Title: LEDs_Switches.SchDoc

Project: KR-Df-01-EL-00.PjrPcb

Title: Revision history.SchDoc		Krakul Akadeemia tee 21/4-304 Tallinn Harju maakond Estonia I 2618		
Project: KR-Df-01-EL-00.PjPcb				
Date: 18/12/2024	Sheet 7 of 7			
Last modified: 18/12/2024	Time: 17:44:55	Size: A3		
Revision:v1		Engineer: IK		
Revision date: 2024-10-24		Checked by: KK

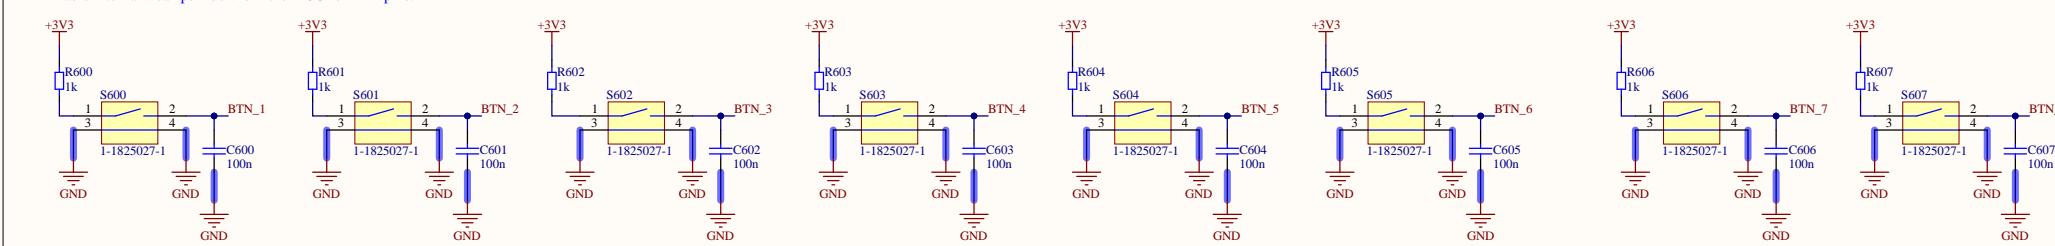
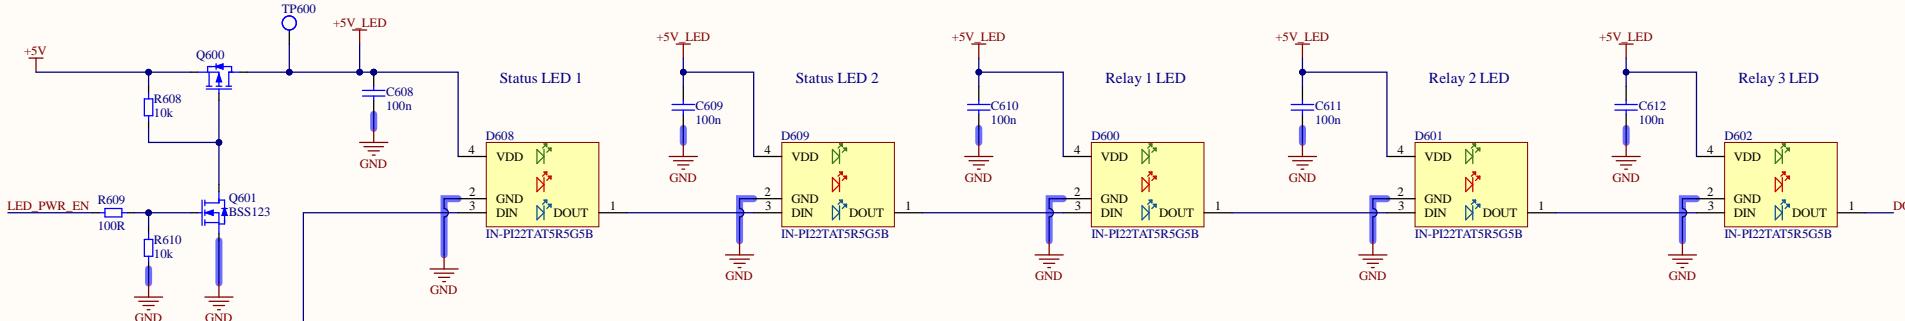
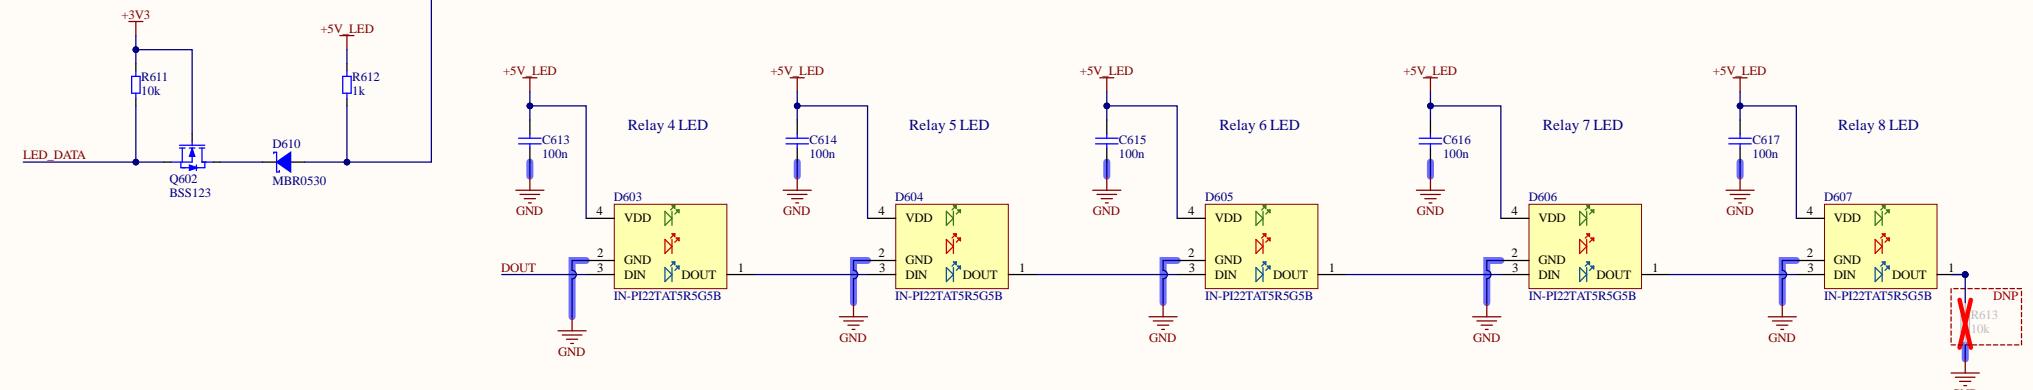
A Repopulate R101, R103, R105, R113, R115, R117
R125, R127
Unpopulate R100, R102, R104, R112, R114, R116
R124, R126

V1
RDB LEDs D600-D608 part number field updated to the correct value
K100-K107 schematic symbol NC/NO orientation fixed and DNP marking moved over the correct resistor.
R514 added a pull-down to U500 pin 94 along with TP505
J300 and J301 pin order changed as RS485 dsub specification suggests. Connections adjusted accordingly.
Added C124-C147 and R148-R155 as part of snubber circuit for the relays
K100-K107 part number replaced with J107F1CS205VDC.45
D600-D609 schematic symbol pin order rearranged according to the manufacturer's documentation.
Added 3V3 LDO for analogue circuits (U401, C440,C441,R412).
Ferrite bead FB500 removed from MCU AVDD path.
Added R413, R414, Q400, R415, D402.
Added mechanical standoffs MH400-MH406
Rearranged P500 pinout to match standard implementation
Split RS485 direction control into two signals from MCU
